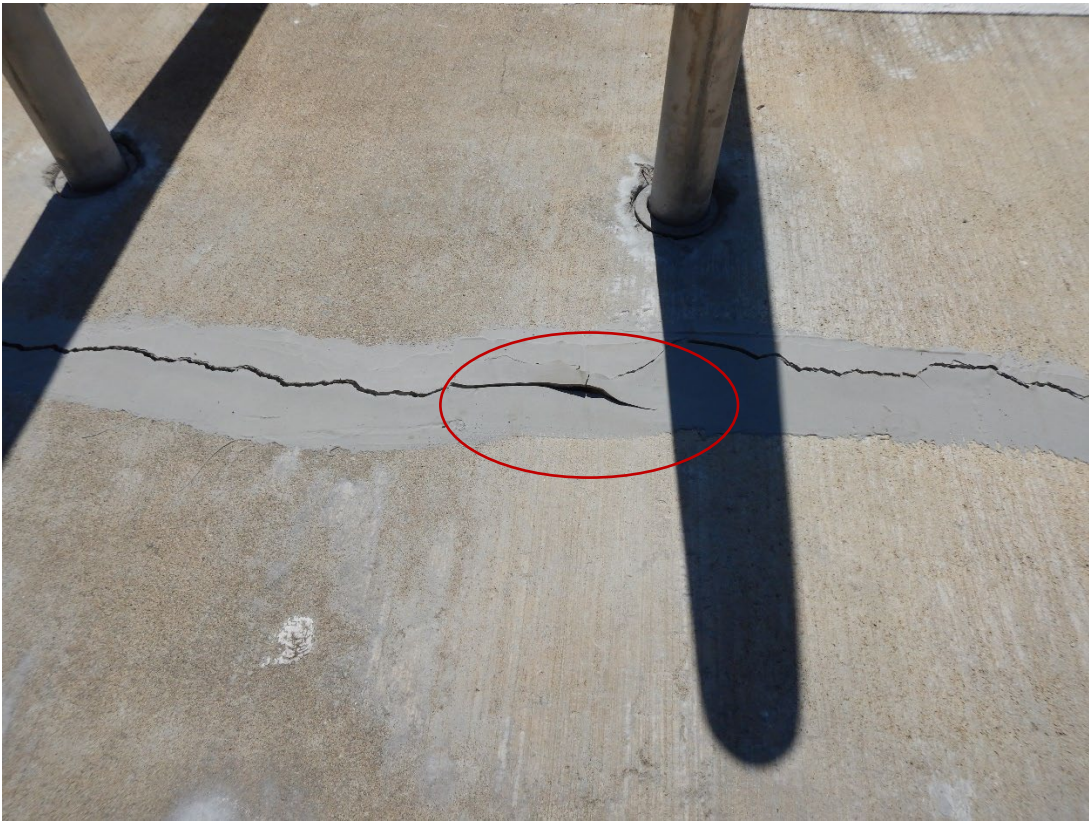
Evaluation Categories	Comments	Fiscal Impact
Deck expansion joints are well sealed and impenetrable	Expansion joints should be resealed. Lack of sealing allows water to penetrate and undermine the integrity of the slabs causing settling, ledges between slabs and unsafe gaps in the pool deck. When resealing, use foam backing rod, or "green rod" stuffed into the joint with a ½ inch to ¾ inch gap to deck level, then seal with a sealant product such as Deck-O-Seal	\$500 sealant plus man hours

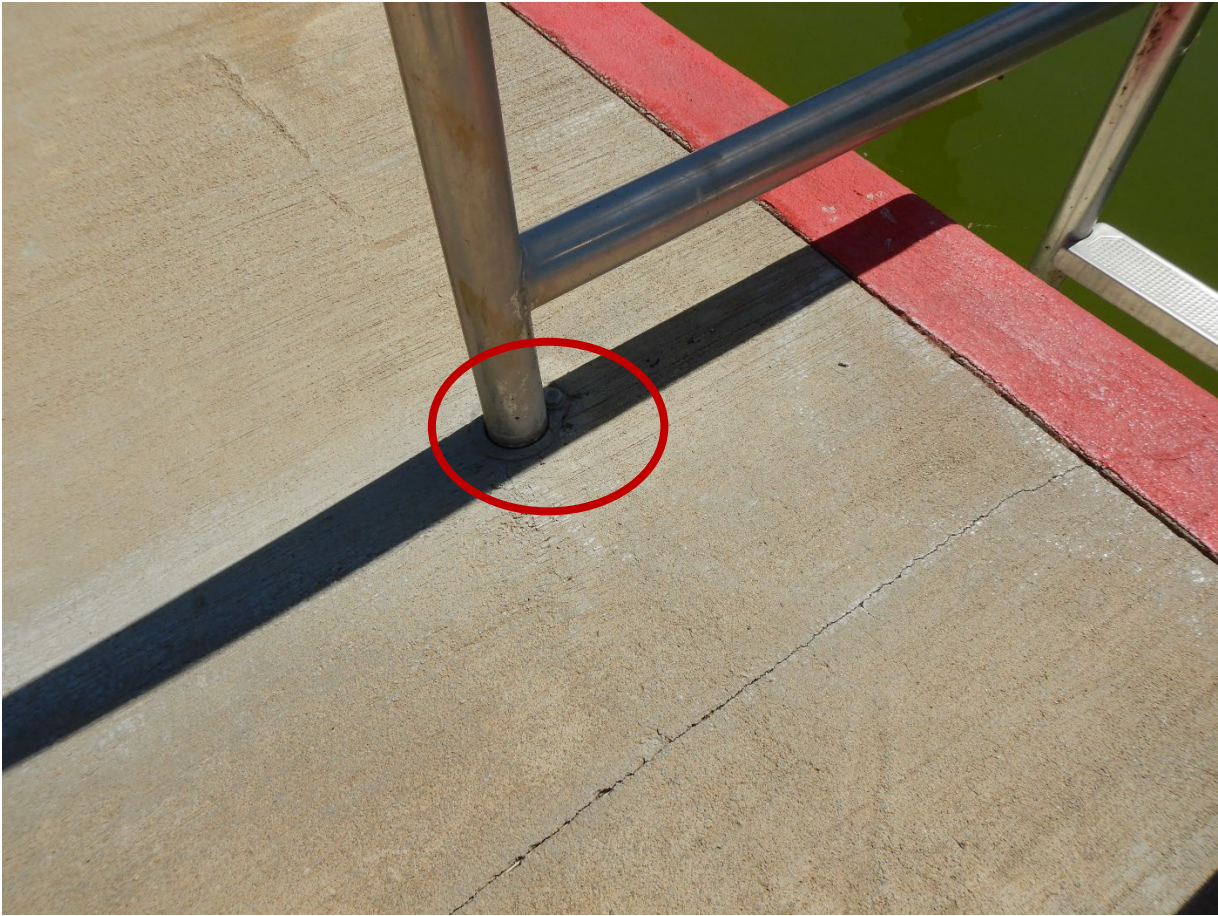
Evaluation Categories	Comments	Fiscal Impact
Functional lifeguard stands, includes; steps, rails, platforms, seat and no potential "strap hooks"	Remove these stands and make the deck flush where they were mounted, they are very old, seem slightly "home modified" and if someone was injured by one it could be the fault of the operator of the facility. Consider portable stands, 6 feet tall, two of them. They can be moved near the pool when needed and moved back when not in use. They can be locked to a fence or rail at night. Having permanent chairs is not good as if you have them you should always have Lifeguards in them whenever the pool is in use.	\$6,000 each, total \$12,000
